PLAN 3

PLANNING APPLICATION PLN-18-0246

60-62 FREDERICK STREET, PERTH

Email to applicant – Planning review PLN-18-0246, Multiple Dwellings x8, 60-62 Frederick

Fig 4.1a – View from proposed new access to the EAST– approximate

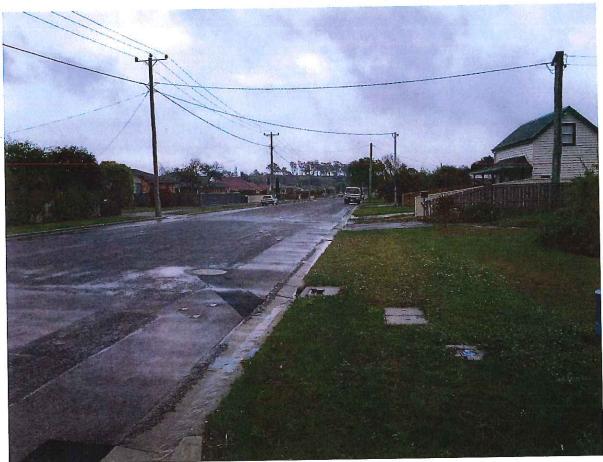
SISD in excess of 150m is available to the WEST and in excess of 250m is available to the EAST, back generally to the junction with Main Road. Whilst visibility can be obscured slightly by parked vehicles, based on the low volume of traffic, the set back of fence alignment and there being few other obstructions in this zone, this appears representative of the remainder of Frederick Street accesses and residential streets elsewhere, and is thus deemed acceptable. On this basis no parking restrictions are considered necessary in the immediate area adjacent to the access.

Clause E4.7.4 of the Planning Scheme notes that sight distance for accesses for Acceptable Solution A1 must comply with Safe Intersection Sight Distance (SISD) from table E4.7.4. For an 85% speed of 50 km/hr this SISD is nominally 80m for speed limit < 60 km/hr. Based on above analysis, E4.7.4 is met by A1. Sight distances can be deemed satisfactory for proposed access as proposed, with an access constructed to NMC (LGAT/IPWEA) standard.

DA-181125 01 of 03

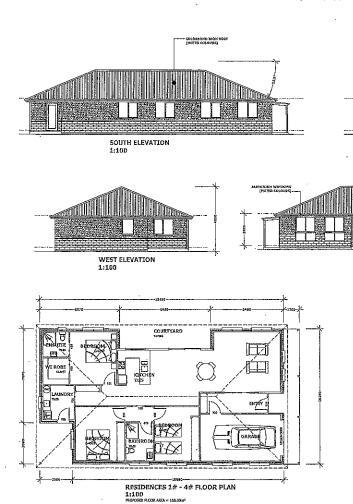
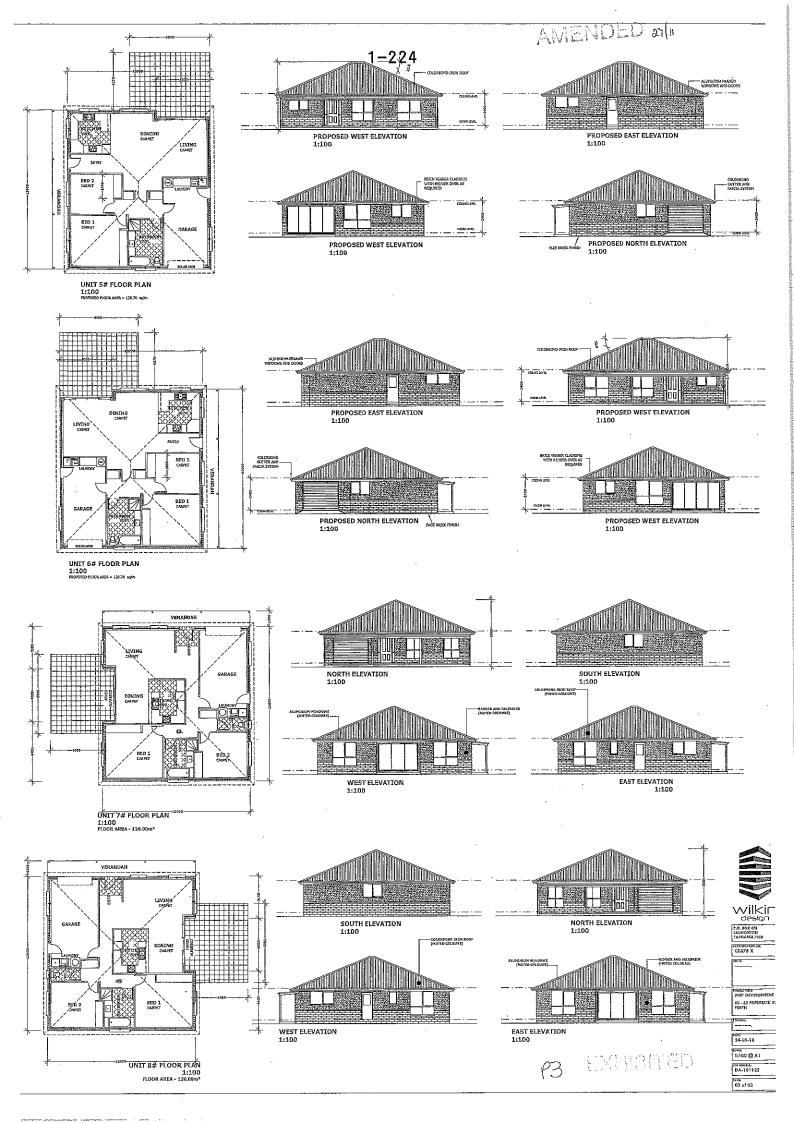
- 10.4.2 A3 (a)(i) Unit 4 varies the southern internal front setback
- 10.4.3 A2 Units 5-8 do not achieve 24m² with minimum horizontal dimension of 4m that is directly accessible from habitable room
- 10.4.4 A1 Units 5 & 6 no north facing windows to habitable rooms (other than bedrooms)
- E4.6.1 A2 Generation of more than 40 vehicle entry and exit movements per day

- Turning templates for visitor parking spaces and unit 3 parking spaces (entry and exit) entire vehicle movement must be able to be undertaken within the sealed area unit 3 may need to be shifted west)
- Traffic Impact Assessment
- Dimensions to show compliance with 10.4.6 A3
- Revised plans to confirm access achieves 4.5m for initial 7m and passing bay and tapers or as per area shown as 'sealed' (if the latter, remove notations regarding minimum widths/dotted line)
- Floor plans for units 7 & 8
- Corrected land area (as per title) and site coverage
- Levels of stormwater infrastructure and on-site detention (discuss with Jonathan Galbraith to confirm exact requirements)

- Corrected owner details on application form (the owner is A.C.N. 124 959 397 Pty Ltd, not JID)
- Corrected elevations/floor plan for units 7 & 8 (swap)
- Corrected parking (width of 2nd outside parking spaces for units 4, 5 & 6 & visitor space near
 unit 4 are non compliant and turning templates are required for northern most visitor
 parking space/s)
- Dimensions of garden areas to show compliance with 10.4.6 A3 (space between habitable room windows and communal access areas).
